Bid Bulletin No. 4 MODIFICATIONS IN THE INVITATION TO BID AND PLANS AND REPLY TO QUERIES/CLARIFICATIONS BY BIDDER

This Supplemental/ Bid Bulletin no. 4 dated January 27, 2022 for the project: **“CONSTRUCTION OF FIVE-STOREY RESOURCE MANAGEMENT BUILDING- PHASE 2 (INFRA-2022-01)”**, is issued to modify or amend items in the Bid Document, and to address queries/ clarifications sent by bidders through e-mail in compliance with Section 25.5.1 of the 2016 Revised IRR of RA 9184.

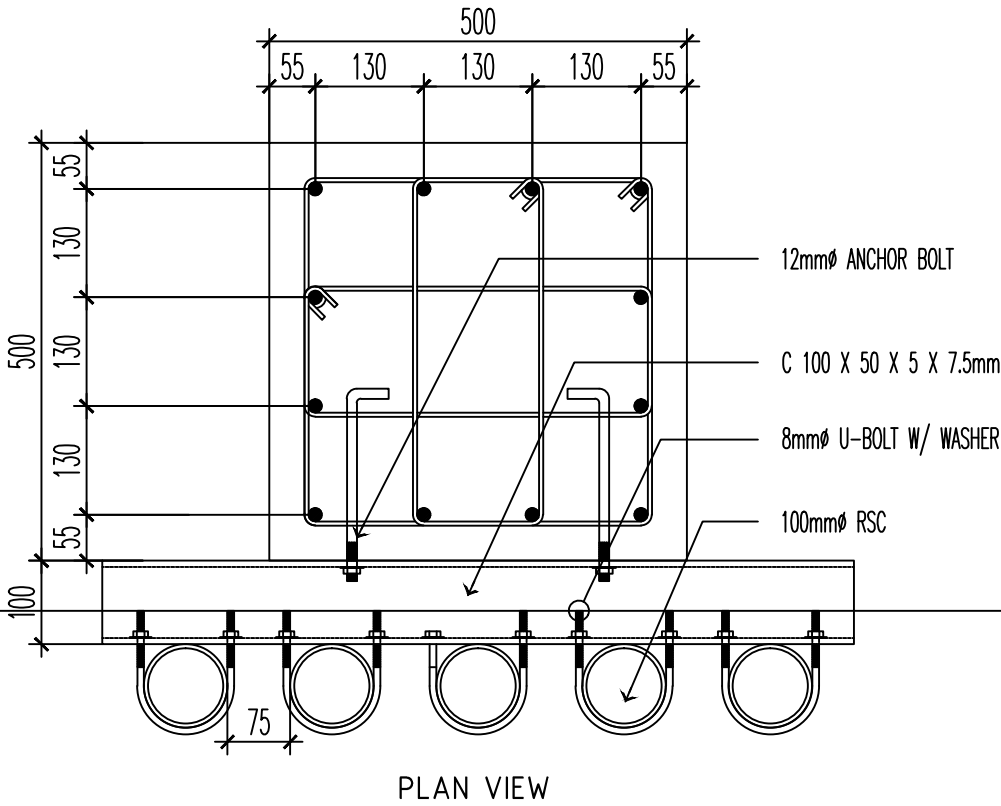
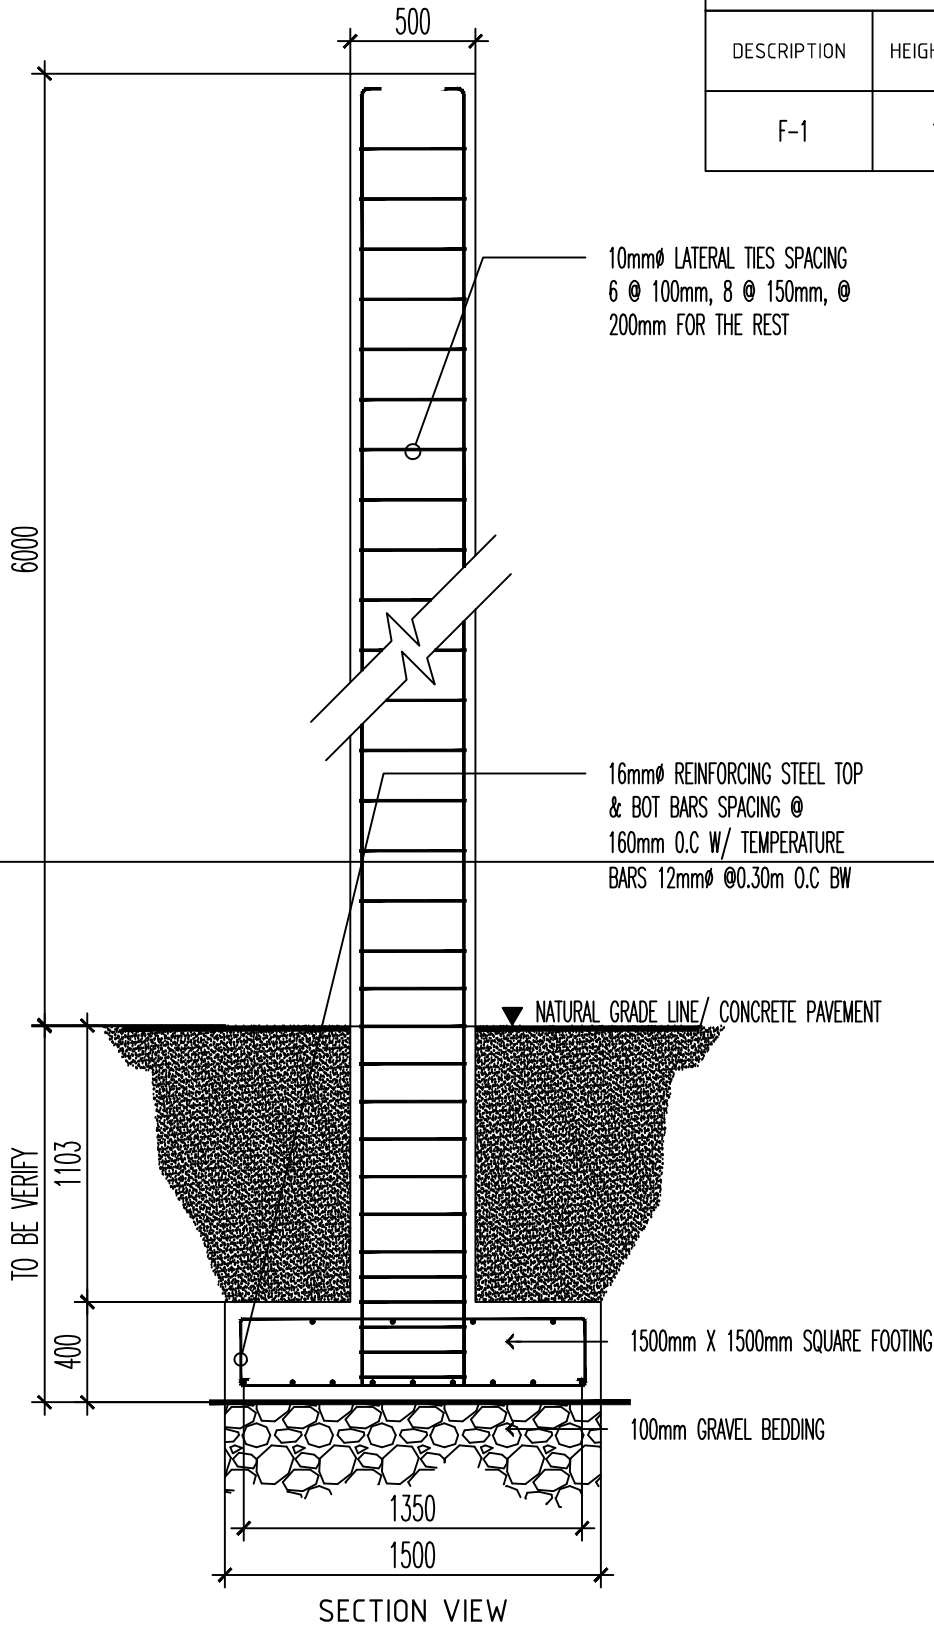
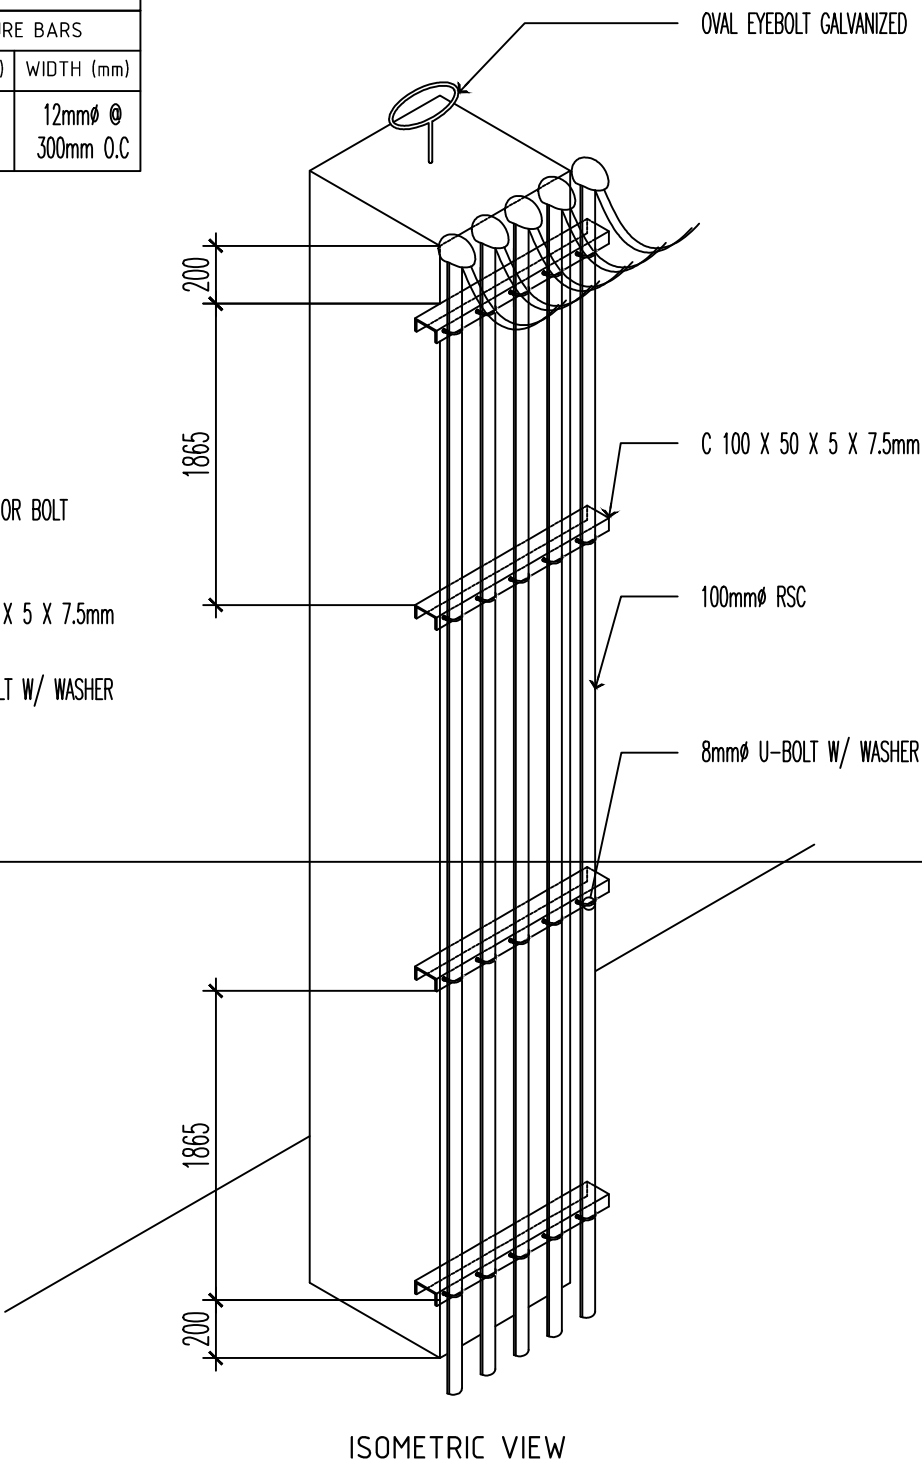
6.	<p>We would like to clarify the limit of Electrical Scope of Work, if Service Entrance Pedestal is include to our scope?</p>	<p><u>All pipes with wires and items in H.3.00 Boxes embedded in slabs and CHB walls are included in the Scope.</u> <u>Service Entrance Pedestal structural component</u></p>

<u>including all embedded bolts are included in Electrical scope. 100mm dia. RSC and steel channel are excluded.</u> <u>Please see attached Annex "A" Drawing</u>
7	Can you pls provide Electrical load schedule	<u>Item A. GENERAL REQUIREMENTS - Design Consultancy (Electrical, ECE, Auxiliary, Fire Protection, Aircon System, Plumbing / Sanitary) is included in the Scope. Design of building's Electrical system including Electrical Load Schedule shall be based on issued Electrical Bid Drawings and shall be finalized by the winning bidder's Professional Electrical Engineer.</u>

500mm X 500mm W/ 12-16mmØ VERTICAL BARS W/ 3-10mmØ LATERAL TIES SPACING 6 @ 100mm, 8 @ 150mm, @200mm FOR THE REST.
